662 TYPE TELEPHONE SET CONNECTING DIAGRAM
 SCALE NONE

WESTERN ELECTRIC CO. INC.
 ENGINEER OF MANUFACTURE

6S
 A-579876

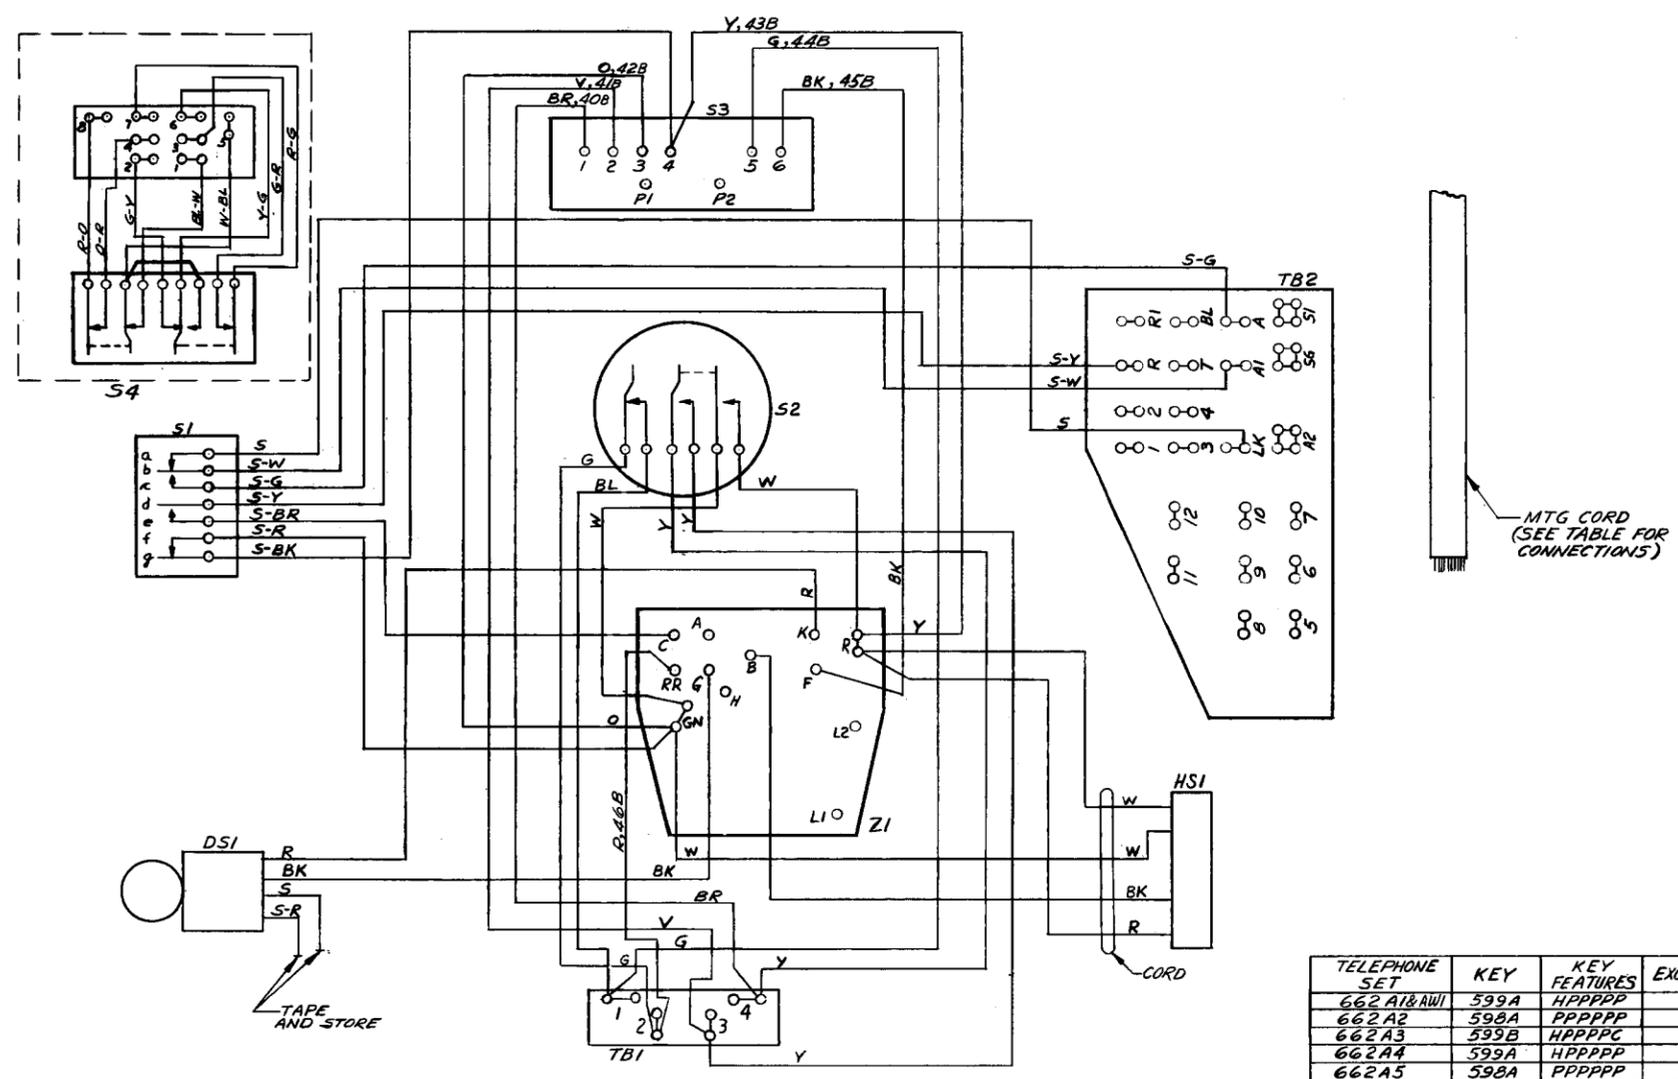
CHANGED IN TABLE. O-V & V-O WERE INTERCHANGED
 L.F. REED 590243AC
 6-26-62

CHANGED: THE BL-W, G-Y, G-R, O-R, W-BL, Y-G, R-G & R-O LEADS CONN. TO TERMS 1 THRU 8 OF TERM. BOARD OF S4 WERE CONN. TO TERMS 4, 2, 5, 7, 8, 1, 6 & 3 RESP.; G LEAD FROM S2 TO TERM. 2 OF TBI WAS ASSEM. FROM S2 TO TERM. RR OF Z1
 ADDED: R-46B LEAD
 L.F. REED 443037A1
 10-20-62 W 3

CHANGED: BR-Y & V-BR MFG. CORD LEADS WERE TAPED & STORED.
 NO. 591472-BL
 7-5-63 W 4

CHANGED: 662 TYPE (3 PLACES) WERE 662A1 & 662A5
 662A1
 M.L.T. E.P. 662A1 TEL SET
 11-6-63 W 5

CHANGED: TBI WMS AS SHOWN BELOW:
